PLANNING REVIEW CHECKLIST

Subject Property: 5730 Lone Oak Road SE

Reference Nos.: 21-122528-LD (UGA Preliminary Declaration)
21-122530-LD (Subdivision)
21-122532-ZO (Class 2 Zoning Adjustment)
21-122538 (Tree Conservation Plan)

LOT LAYOUT PLAN

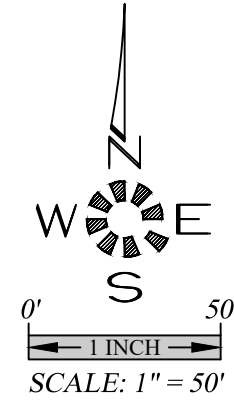
Min. 30 feet of street frontage required on cul-de-sac turnaround; provided, however, the width of the lot at the front setback line (12 ft.) must be a minimum of 40 ft.

Lot 21 is not a flag lot and is required to meet the min. 30 feet of street frontage required on cul-de-sac turnaround provided; however, the width of the lot at the front setback line (12 ft.) shall be a minimum of 40 ft.

Lot area exclusive of flag lot accessway needs to be shown on plan as well.

Lot area exclusive of flag lot accessway needs to be shown on plan as well.

PW has safety and sight distance concerns about a connection of Sarah Renee Avenue to Lone Oak Street at this location.

Existing ROW width does not meet current 60-foot standard (Alternative Street Standard required to allow existing 51-foot ROW)

Lots 29 to 33 will not have access unless approval is obtained to dedicate right-of-way and construct the identified improvement of Sarah Renee Avenue SE on the abutting property to the south. Confirmation is needed whether the abutting property owner to the south has agreed to the dedication of right-of-way and the construction Sarah Renee Avenue across their property.

Property proposed to be rezoned to MU-II (Mixed-Use) under the Our Salem Project. If the property is rezoned to MU-II an alternative street connection of Sarah Renee to Lone Oak further to the south to improve sight distance may not be feasible do due to the street right-of-way width, the size of the property, and the uses permitted in the MU-II zone which is other than single family.

If Sarah Renee Avenue cannot connect to Lone Oak Road in the proposed location, further discussion will be required in order to determine how east-west street connectivity for Sarah Renee can be provided.

TREE CONSERVATION
N.W. QUADRANT

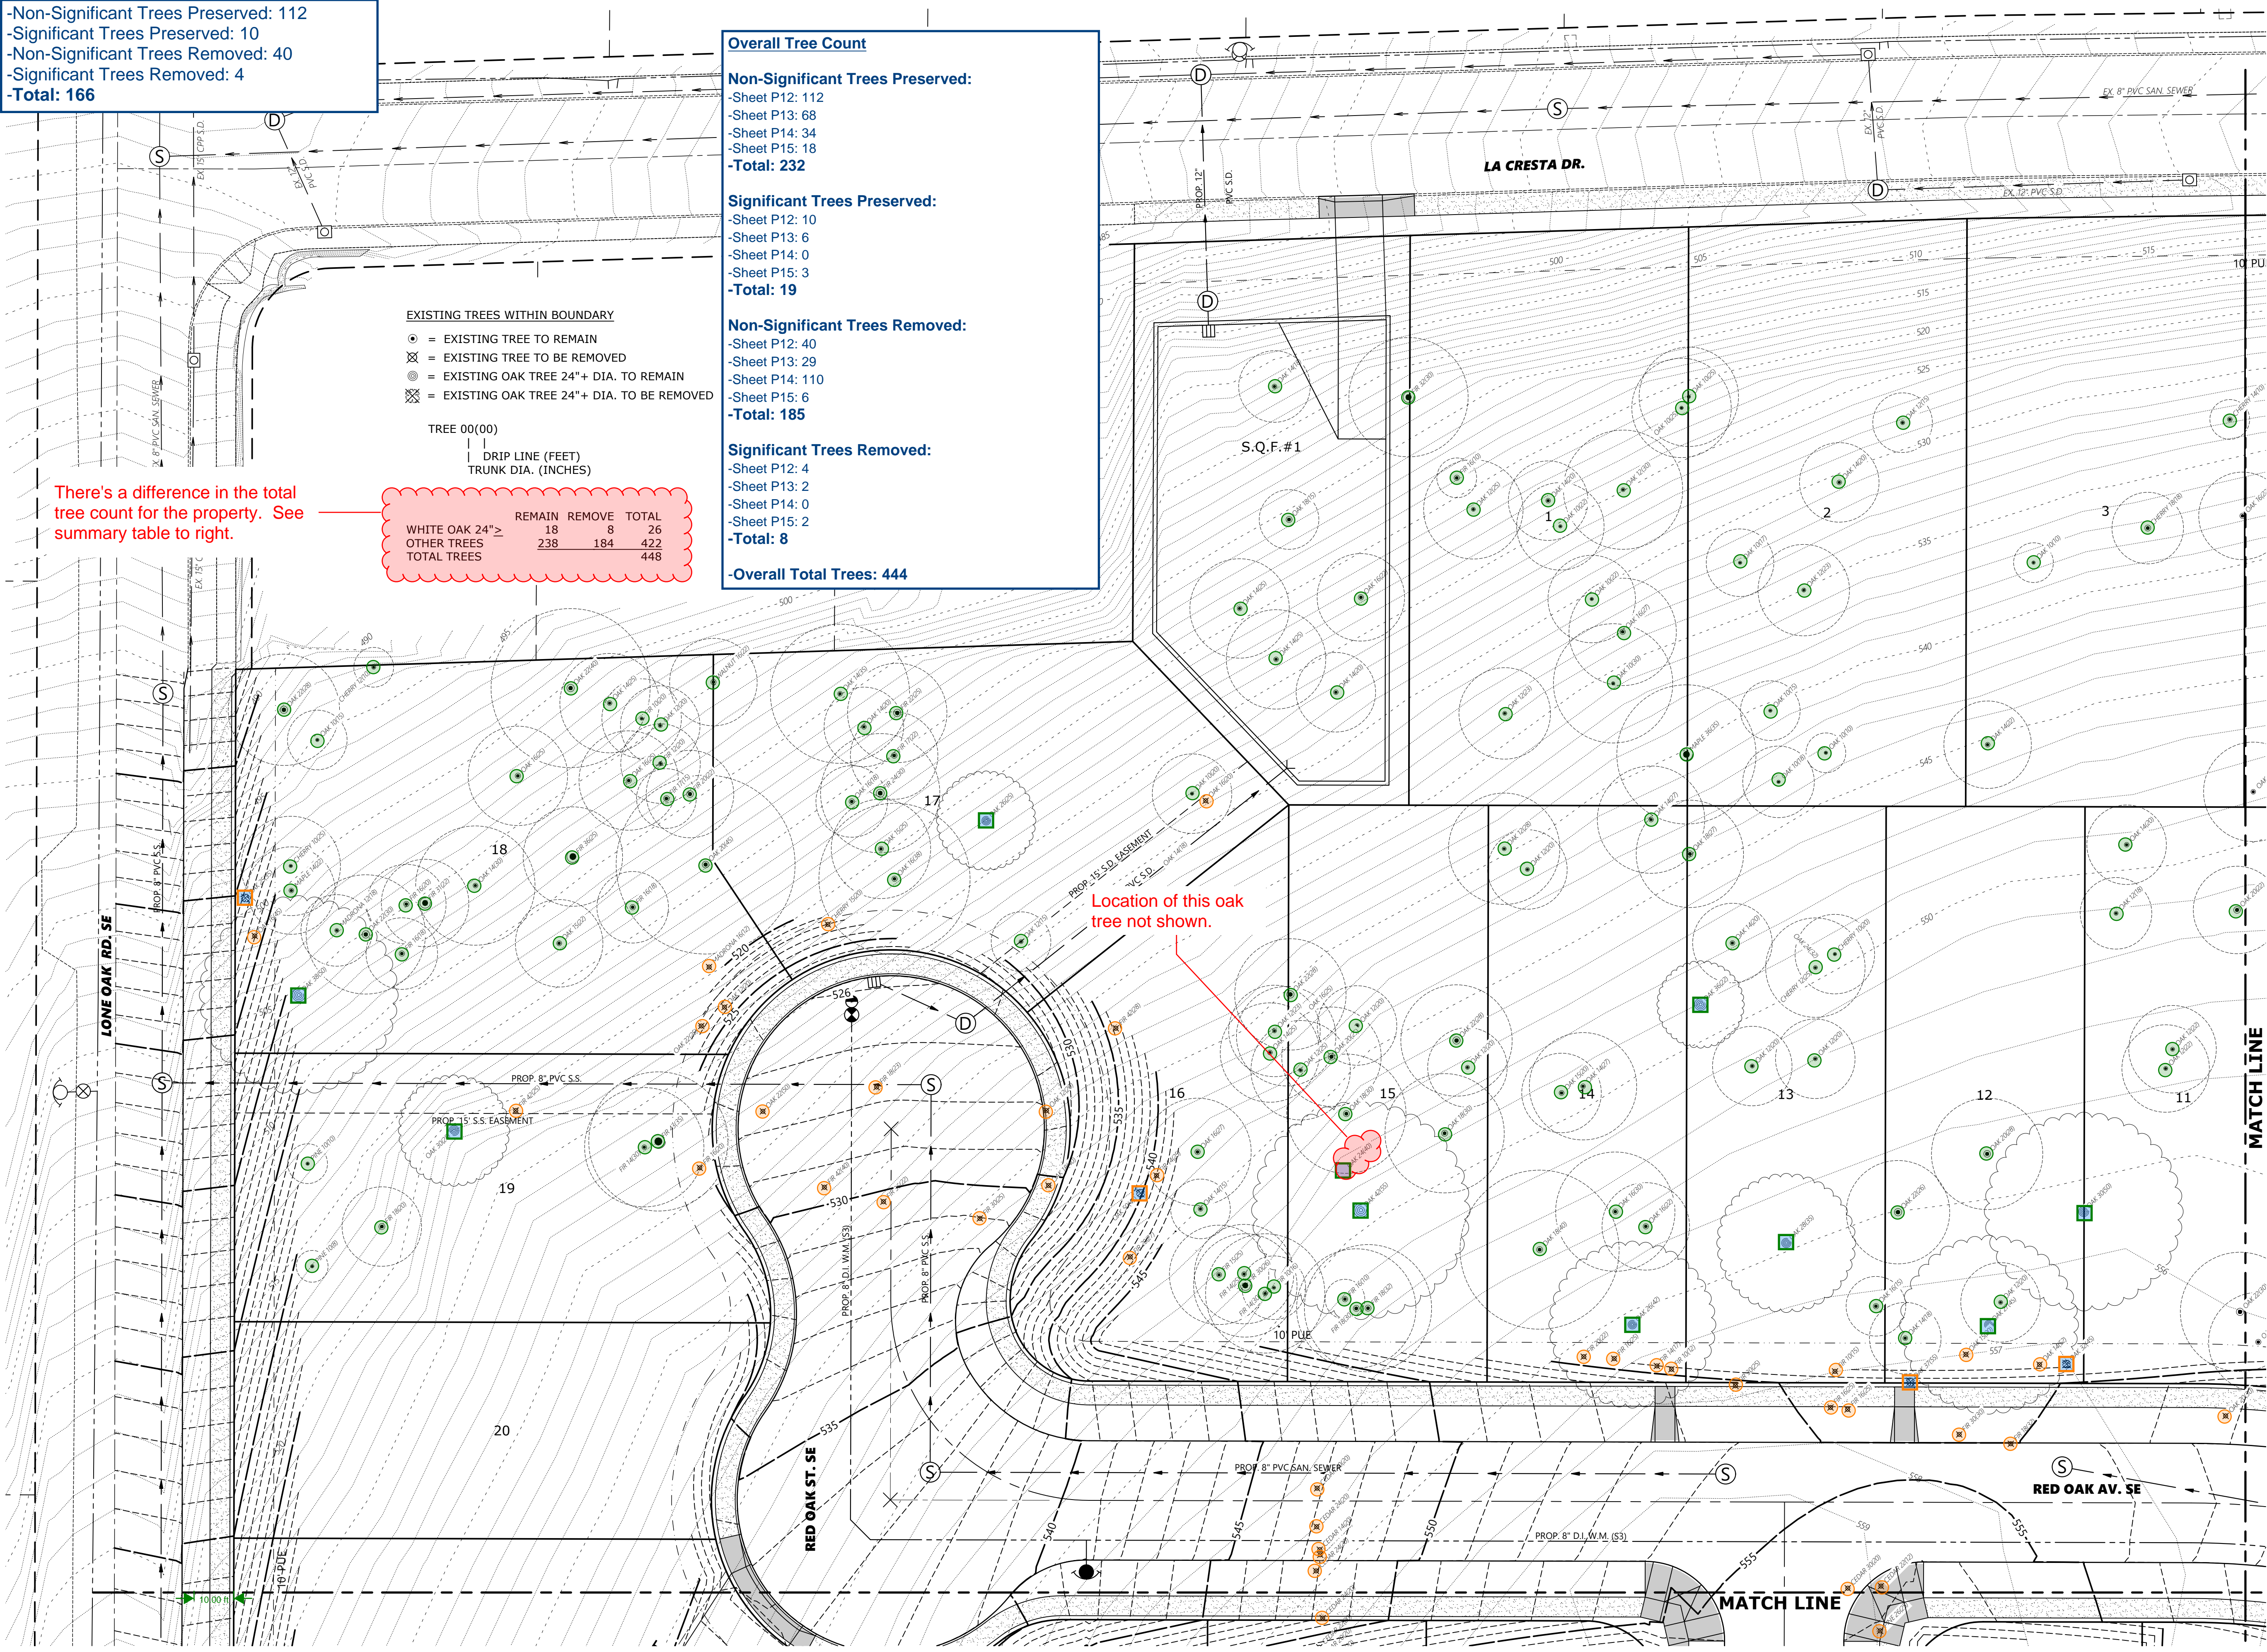
There's a difference in the total tree count for the property. See summary table to right.
